ROYAL CANADIAN AIR FORCE
MODIFICATION

INSTALLATION OF INVERTER RADIO
INTERFERENCE FILTER

BRISTOL AIRCRAFT (WESTERN) LIMITED P.O. BOX 874, WINNIPEG, CANADA	ENGINEERING CHANGE PROPOSAL Preliminary <input type="checkbox"/> Re-issue <input type="checkbox"/> Final <input checked="" type="checkbox"/>	RCAF Modification Number
--	--	--------------------------

1	ECP No. BAW/EXP-008	Date	Contract Demand No. CDW 772810	Articles in Production Yes No X	Est. Effective Date UPON RCAF REQUEST
---	------------------------	------	-----------------------------------	---	--

FIG 1.

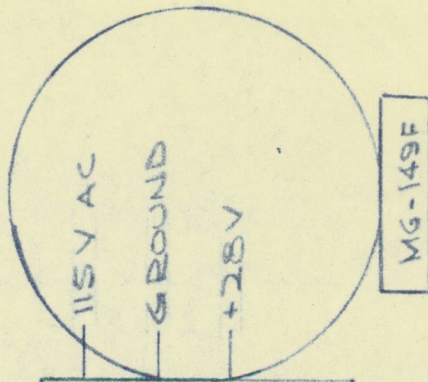
2. a) WHERE THE 2N INVERTER HAS BEEN INSTALLED IT SHOULD BE REPLACED WITH THE MG-149F (REF 5U/1821) INVERTER.
- b) REMOVE INVERTER FILTER COVER.
- c) INSTALL THE BRACKET ON THE INVERTER FILTER COVER AS SHOWN IN FIG. 1.
- d) REPLACE INVERTER FILTER COVER.
- e) INSTALL FILTER BOX AS SHOWN IN FIG 1 CONNECTING CABLE AS SHOWN.

NOTE:
 POSITION TERMINAL BLOCK TO DETERMINE RIVET POSITIONS ON INVERTER FILTER

FIG. 2

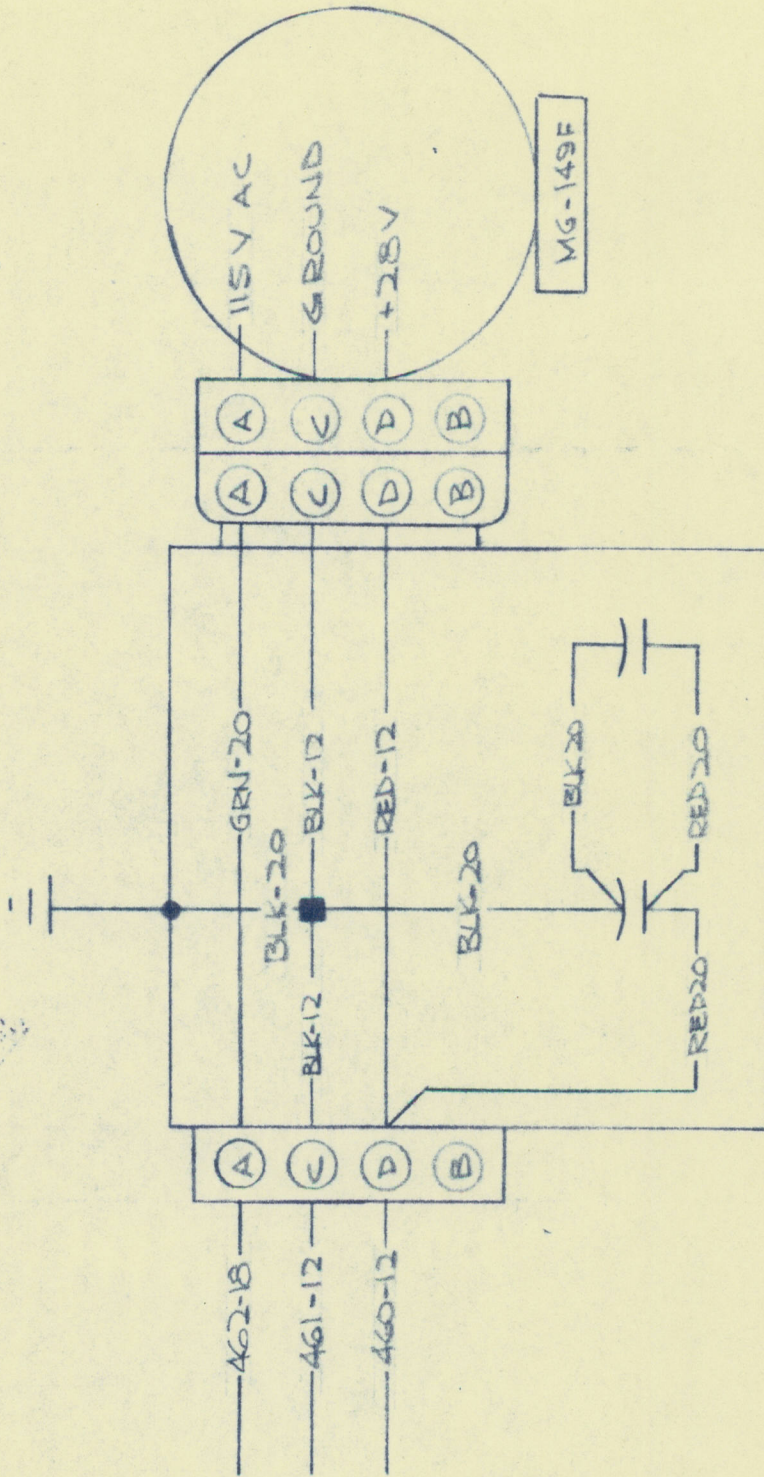
6. a) ENSURE THE INVERTER CABLE IS WIRED IN ACCORDANCE WITH THE WIRING DIAGRAM FIG 2.
- b) THE INVERTER COVER MUST REMAIN WITH THE AIRCRAFT ON CHANGE OF INVERTER & THE NEW COVER PLACED ON THE REPLACED INVERTER.
- c) THIS MODIFICATION APPLYS TO THE MG-149F INVERTER ONLY AS INSTALLED IN THE EXPEDITOR 3.
